From: Cefalo, James
Sent: Saturday, June 8, 2024 8:18 AM
To: Cefalo, James
Subject: Fwd: Elaine Sorensen 2024 Irrigated Acres
Attachments: Ground Water Acres.zip

SUPPORT DATA
IN FILE # 34-170

2024 Irrigated Acres Land List

SORENSEN - 2024 Irrigated Acres

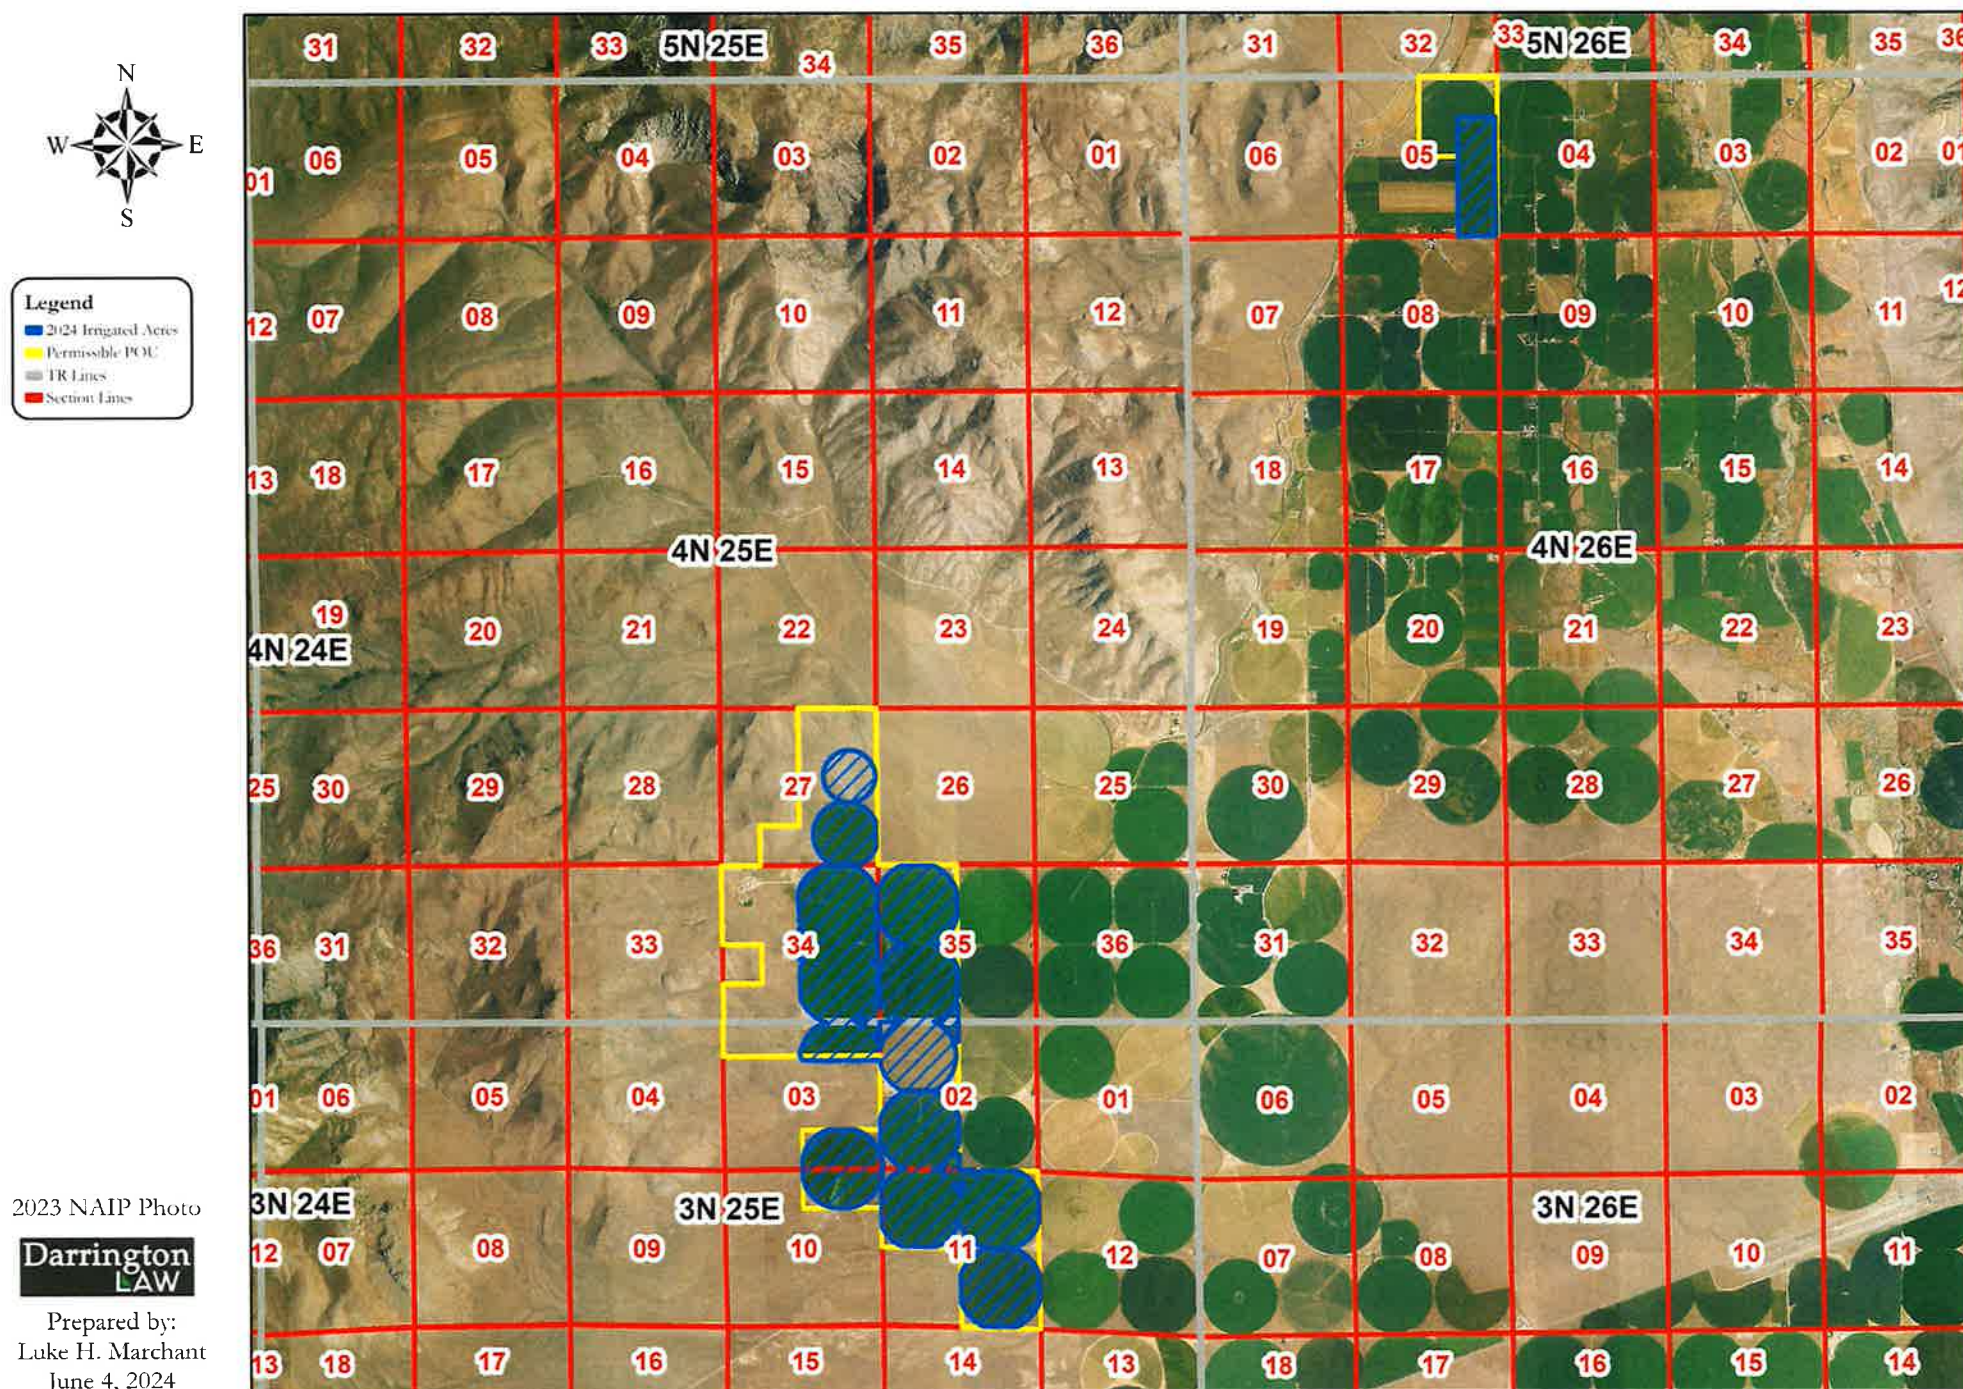
As I updated the map shapes, I discovered some errors.

First, ground water right 34-2424B is not part of the permissible place of use. In Transfer 84270, water right 34-2424B continued to have a separate place of use in the NE1/4 of Section 5, T04N, R26E. I have corrected the map shape for water right 34-2424B to reflect the place of use description for the right.

Second, Transfer 84270 created two shapefile requirements. The water user is required to identify the 1,721-acre shape to be irrigated by all the combined water rights (excluding 34-2424B). The water user is also required to identify the 1,584.5-acre shape to be irrigated by the ground water rights in the permissible place of use. When you sent the updated shape earlier in the year, I inadvertently copied that shape to all the water rights. I may have wiped out the 1,584.5-acre shape for the ground water rights. When you get a moment, can you send me the 1584.5-acre shape for the ground water rights.

I initially forgot that 34-2424B was excluded as well. When I sent my map to you, I forgot to remove that water right pou from the permissible place of use. I have corrected my shapefile to reflect that.

I have also attached the shapefile for the ground water acres. Let me know if you need anything else.

SORENSEN - 2024 Irrigated Acres

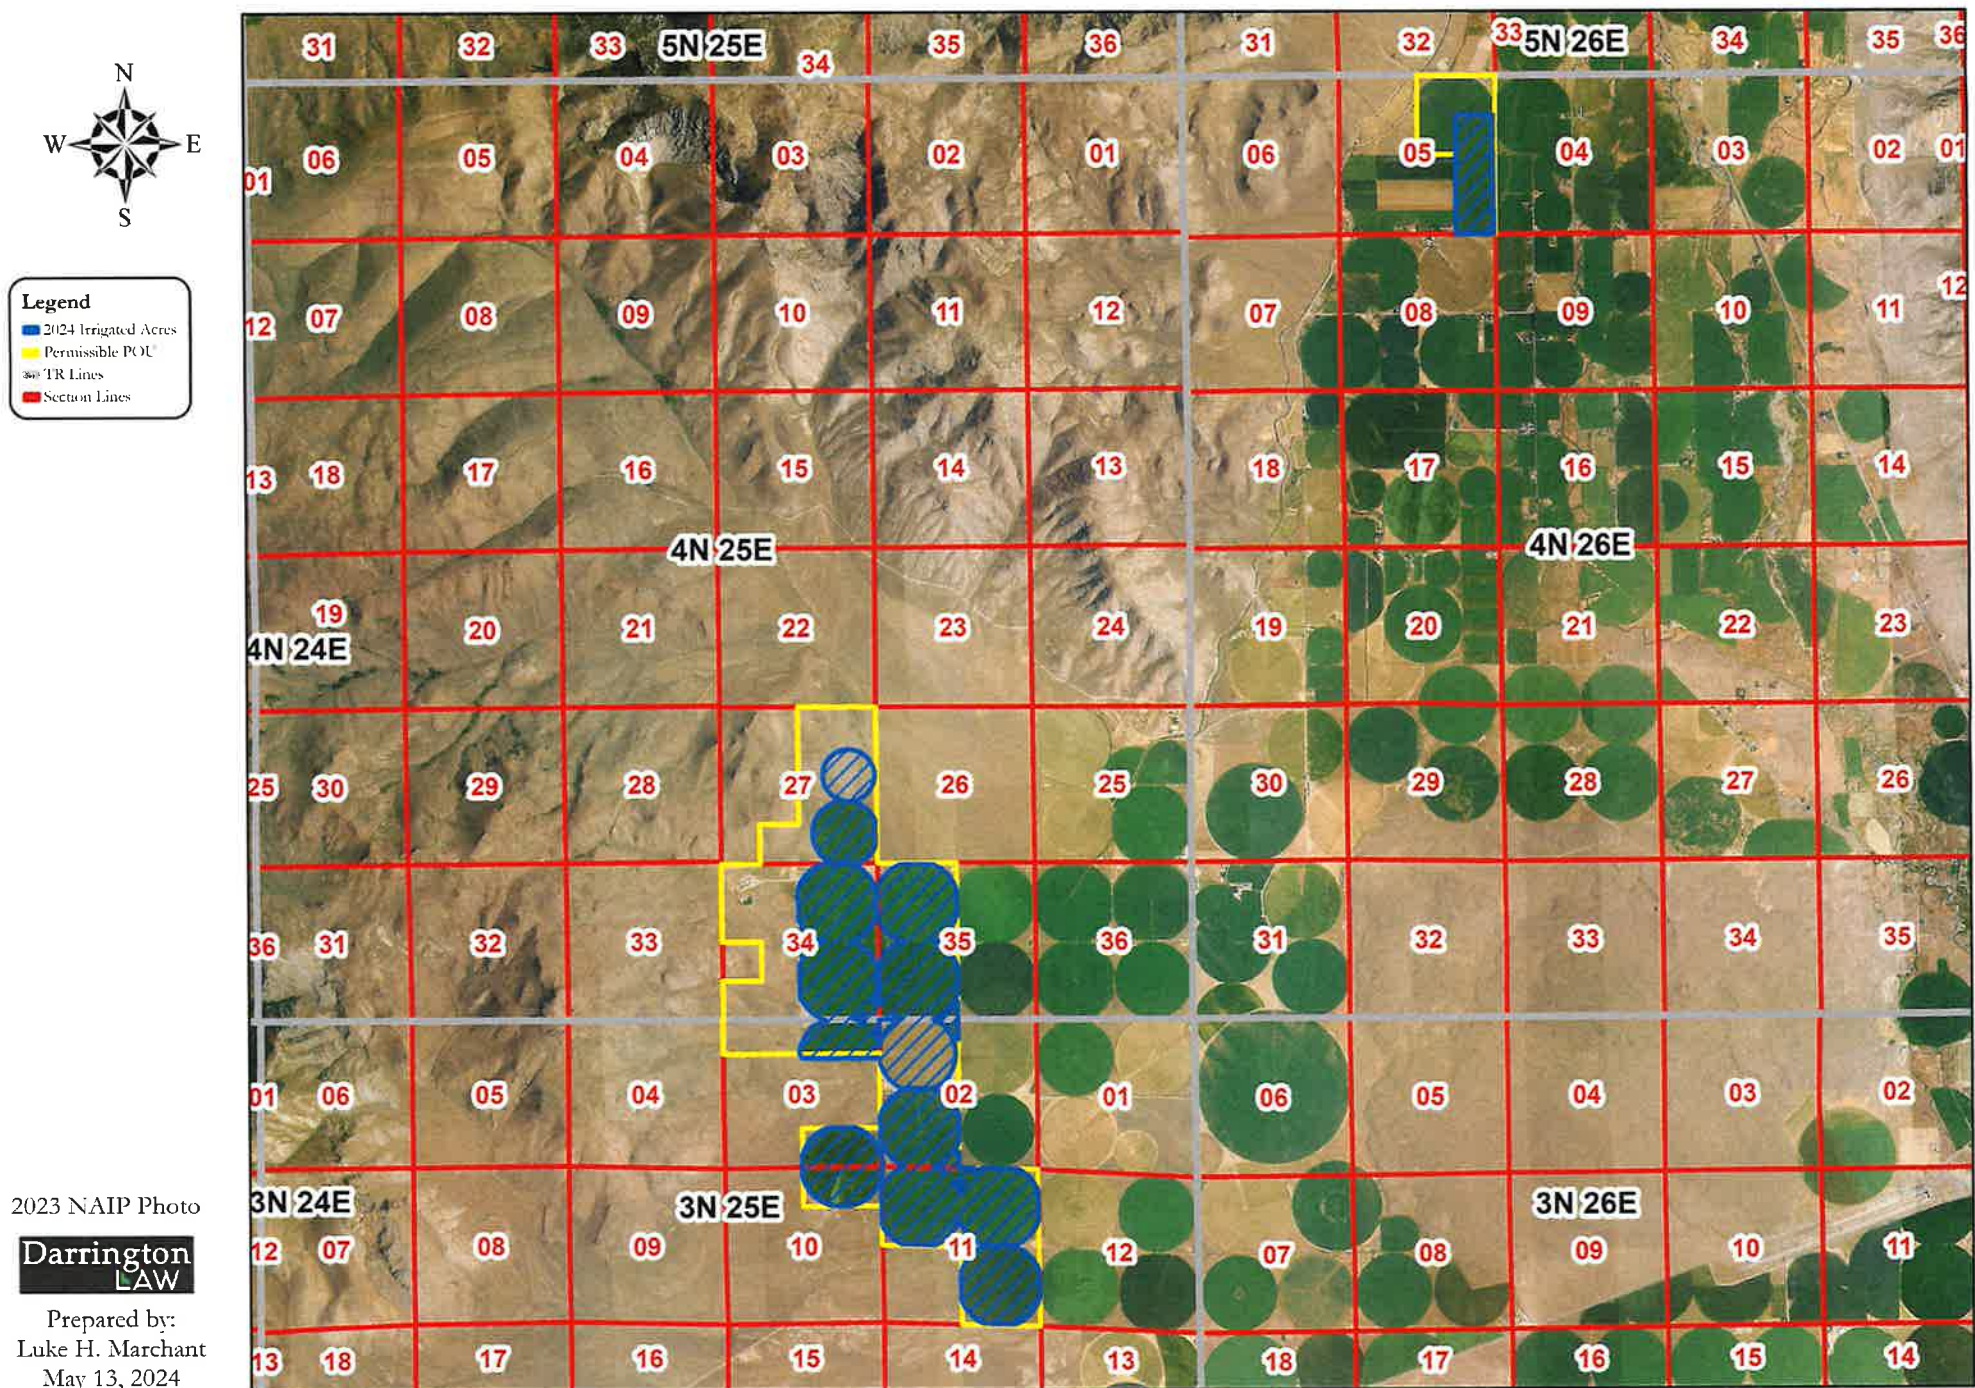
We have made a couple of small changes to the shapefile and spreadsheet which I sent you below. Adam will continue to irrigate a couple of corners with surface water as long as it is in priority. I have added that ground to the map, shapefile, and spreadsheet and attached new versions of those three files for you. If you have any questions, do not hesitate to contact me.
